**Development Application:** Minor Change to Development Permit DA20/21-005 for Carrying Out Operational Work (External Road Works, Internal Road Works and Parking, Earthworks, Stormwater and Drainage Works and Water Supply Connection)

Referred to in Council's Decision Notice

# Thomson River Caravan Park Locality Plan

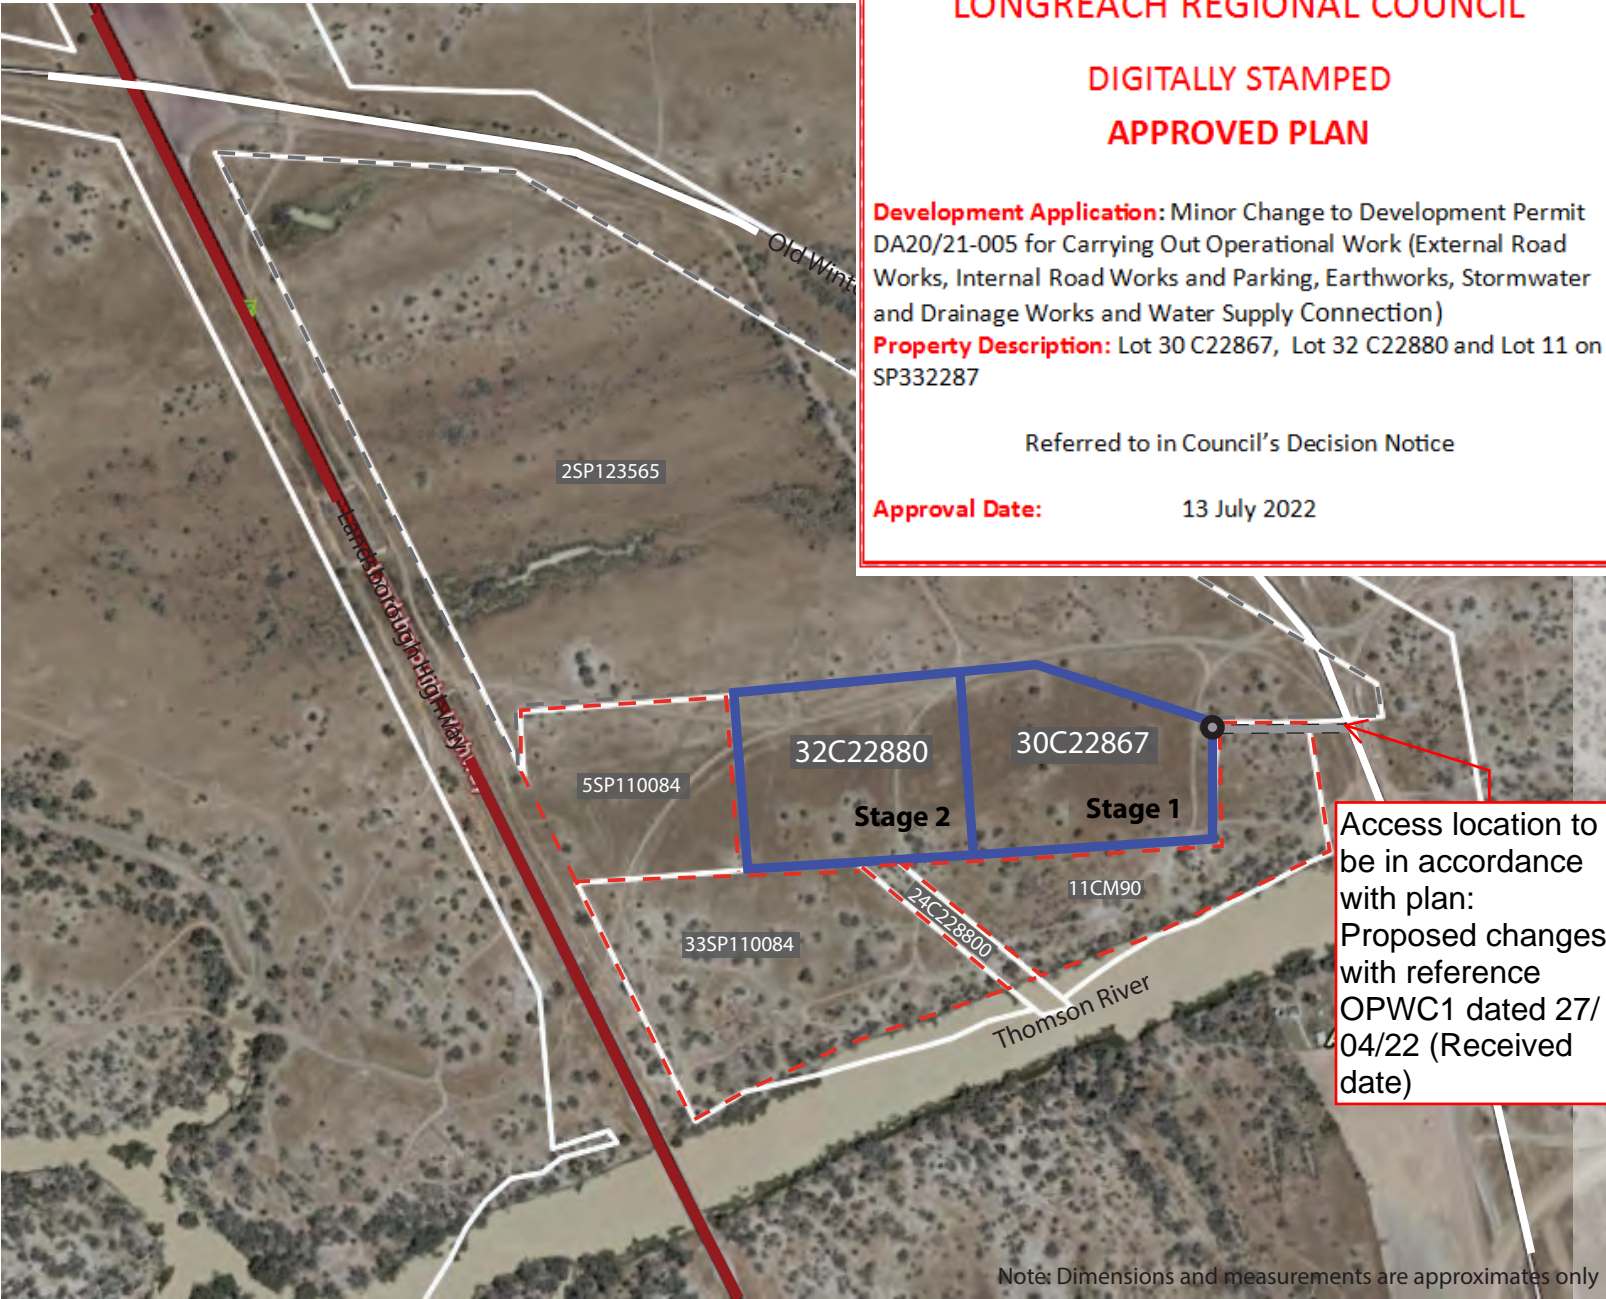
Amended in red by Council  
08/07/22

Access location to be in accordance with plan:  
Proposed changes with reference OPWC1 dated 27/04/22 (Received date)

P.O. Box 554 Beaudesert QLD 4285		<b>ACS Engineers</b> CIVIL   ENVIRONMENTAL   PROJECT MANAGEMENT
(07) 5541 3500 www.acsengineers.com.au		
JOB NUMBER	200109	A
DRAWING NUMBER	ACS-200109-GEN-02	
		02 OF 13

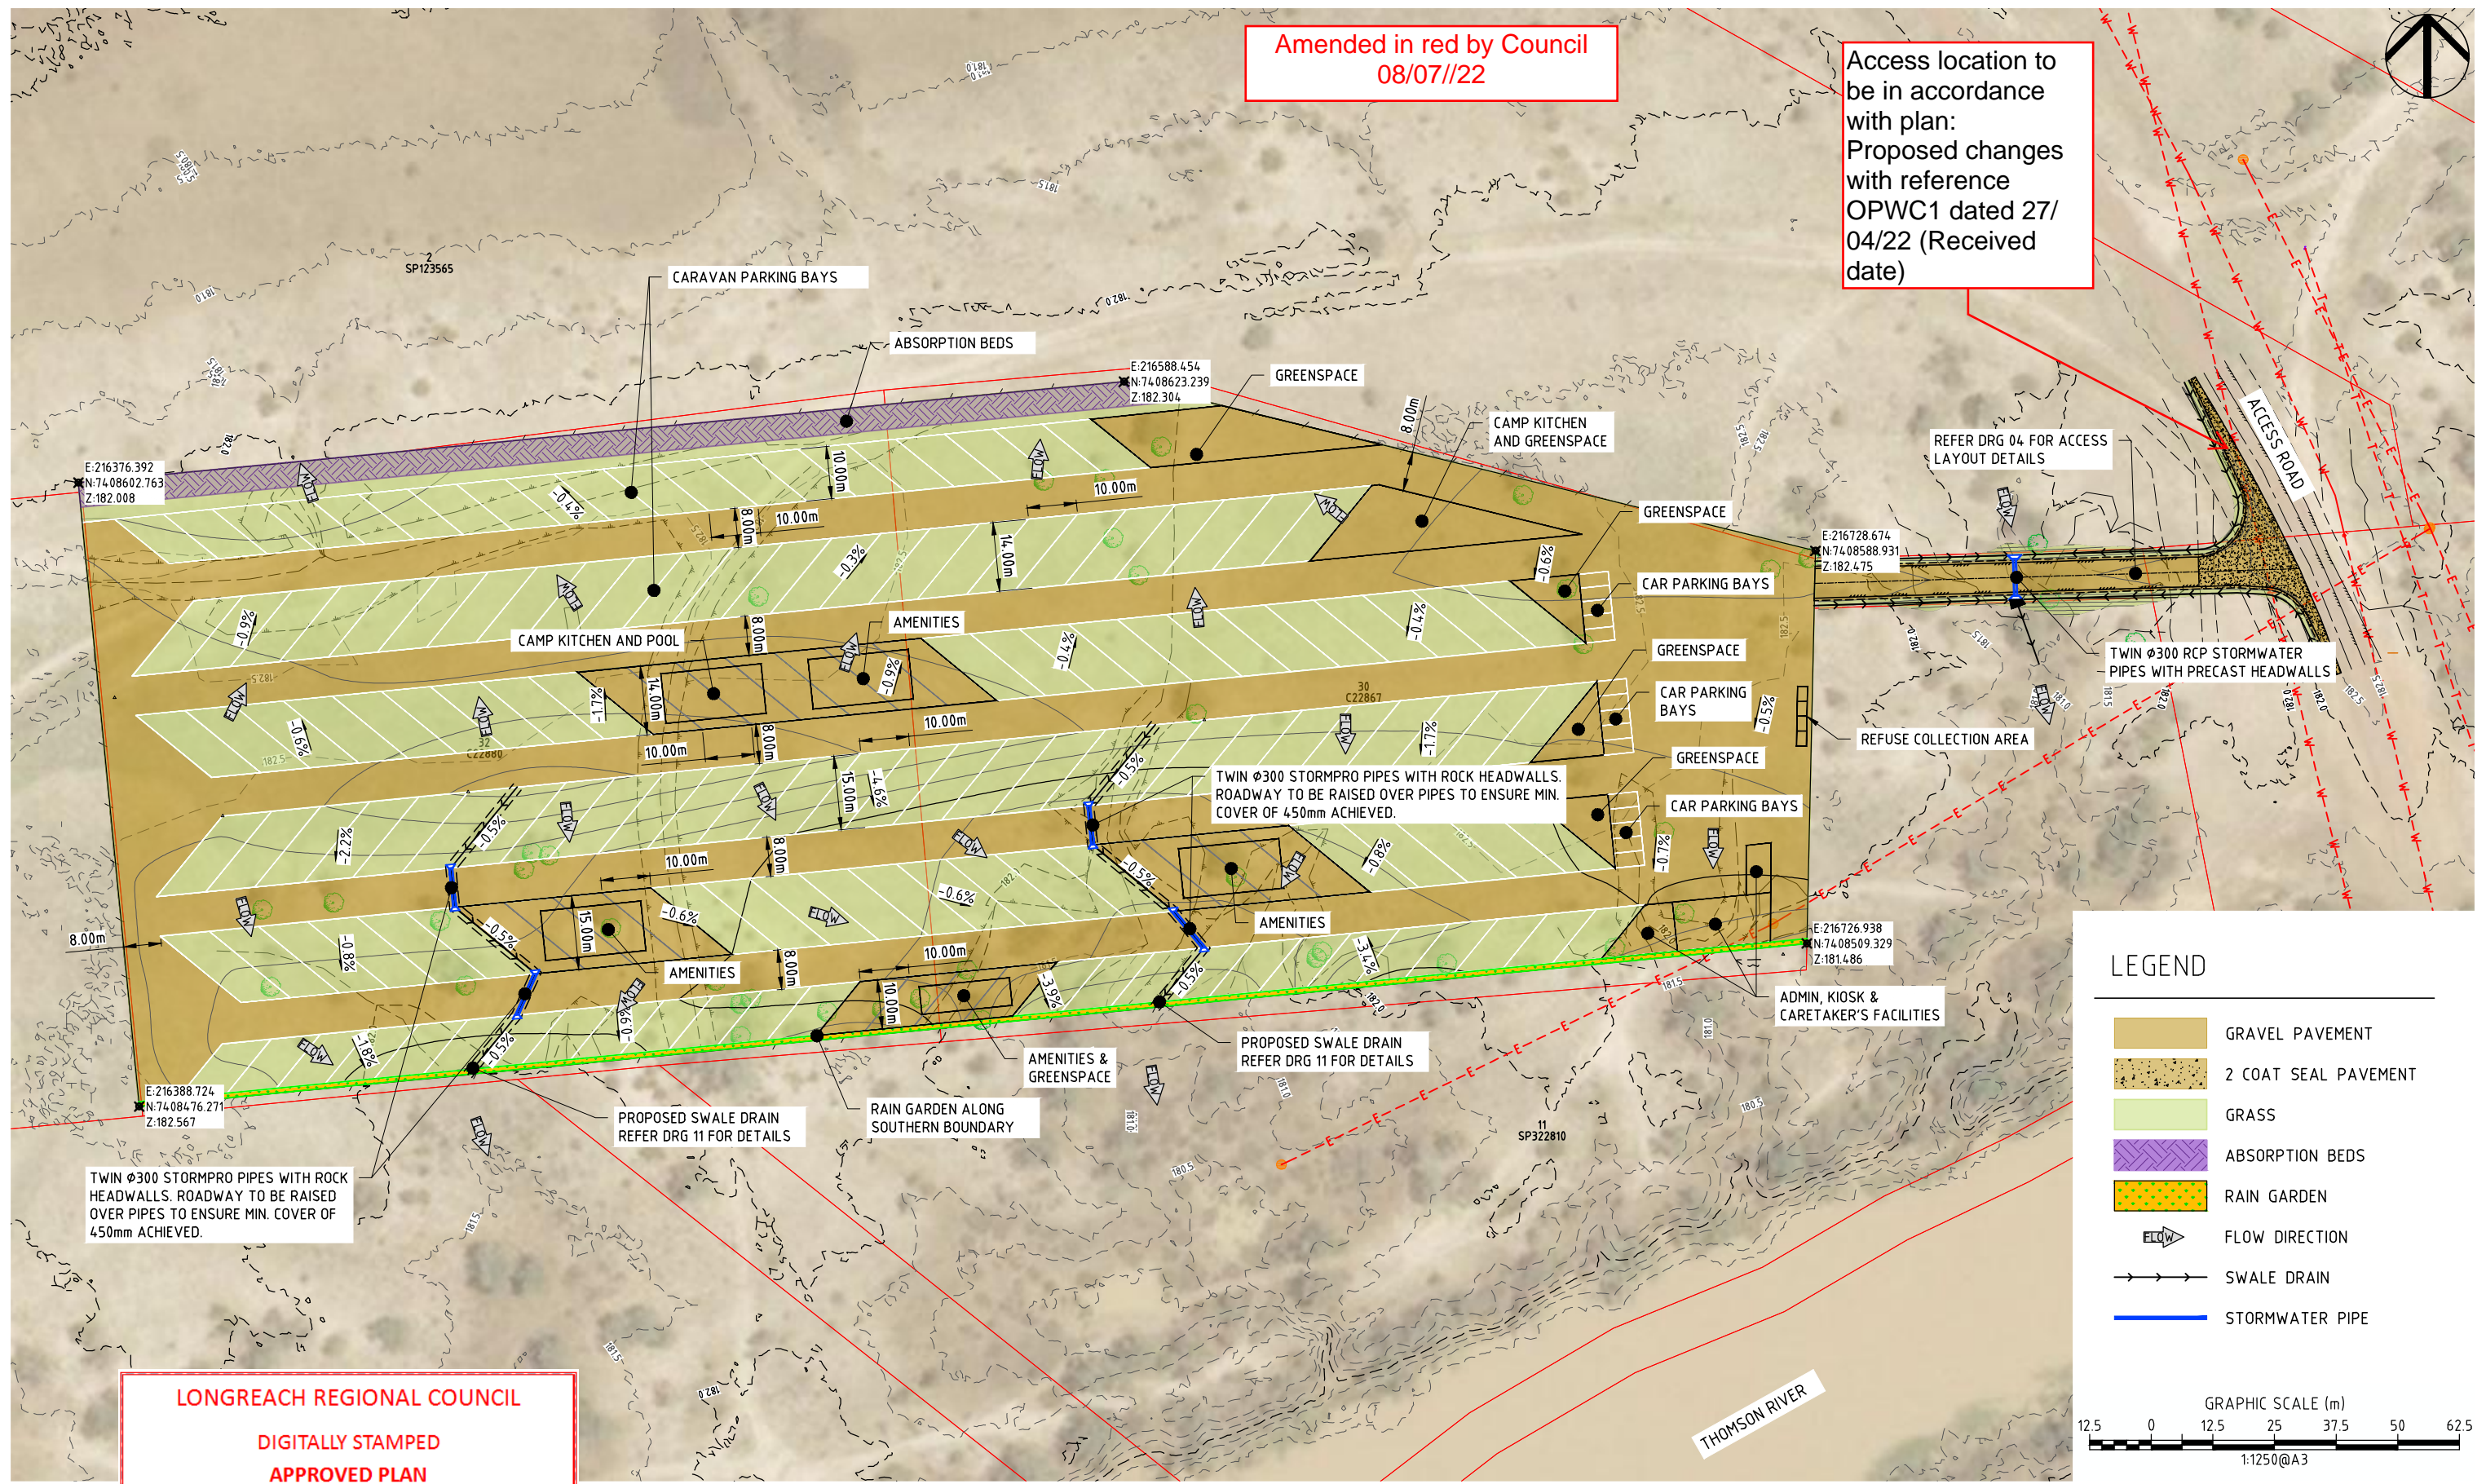
Amended in red by Council  
08/07/22

Access location to be in accordance with plan:  
Proposed changes with reference OPWC1 dated 27/04/22 (Received date)

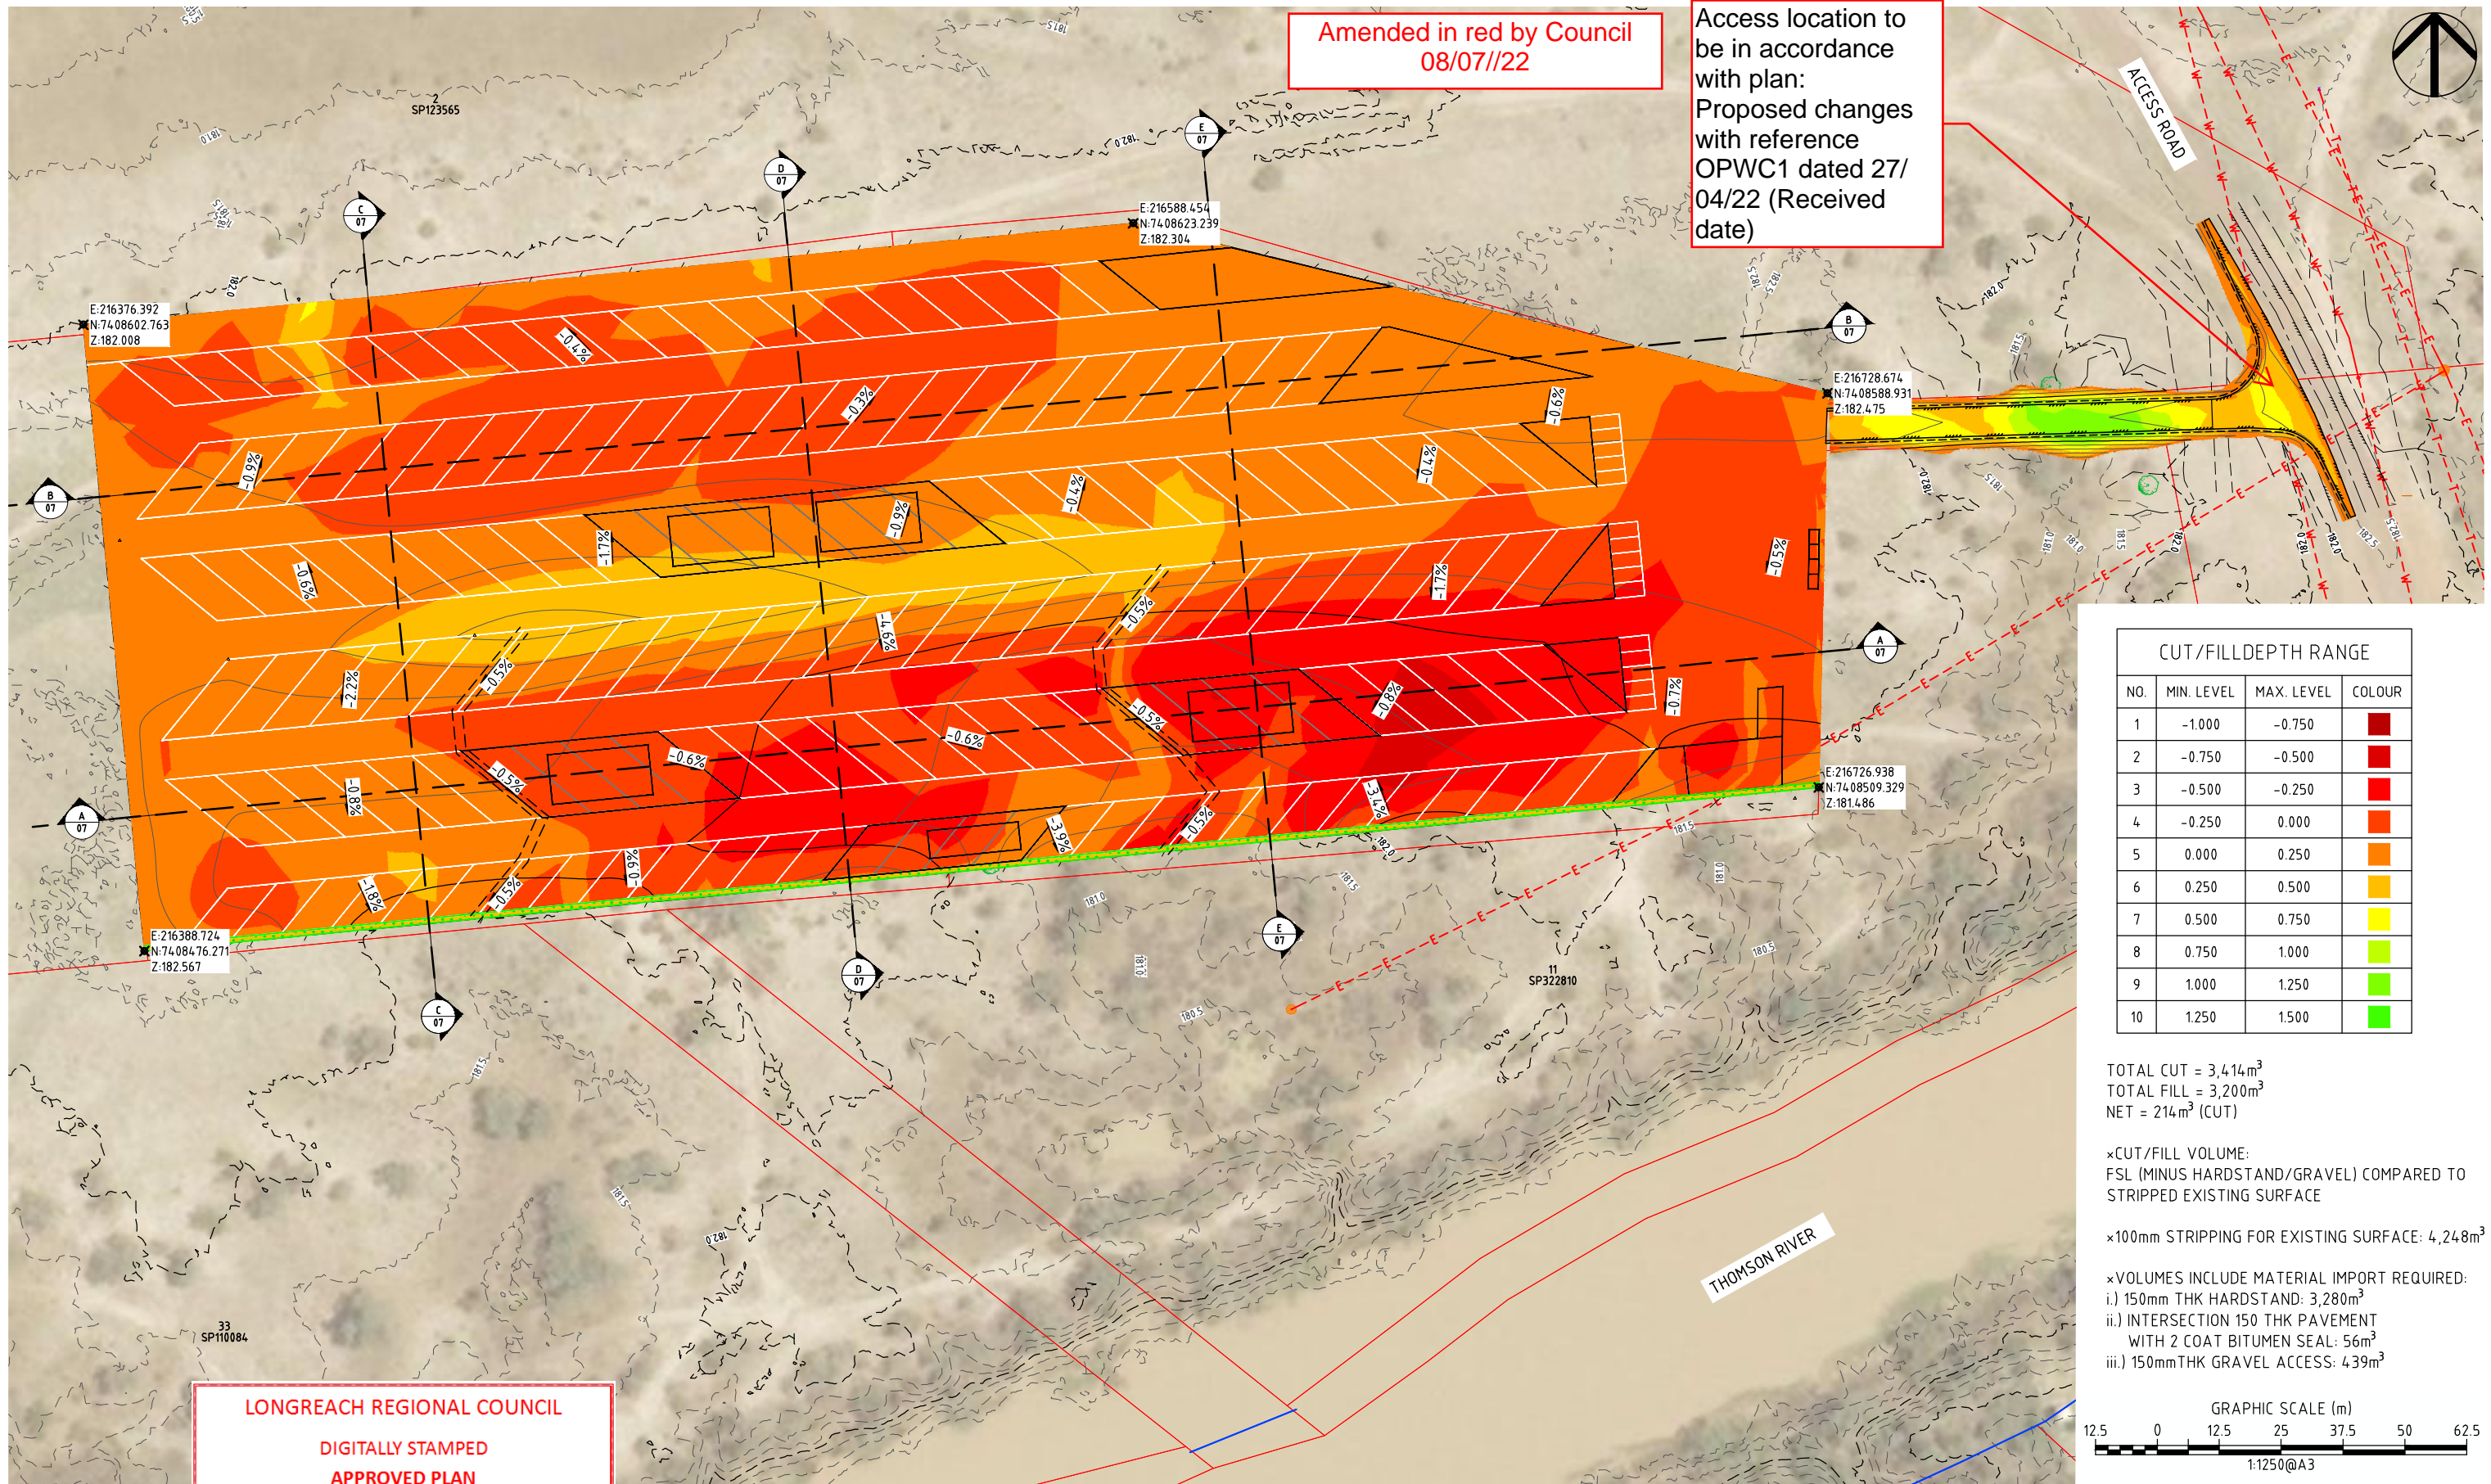
Amended in red by Council  
08/07/22

Access location to be in accordance with plan:  
Proposed changes with reference OPWC1 dated 27/04/22 (Received date)
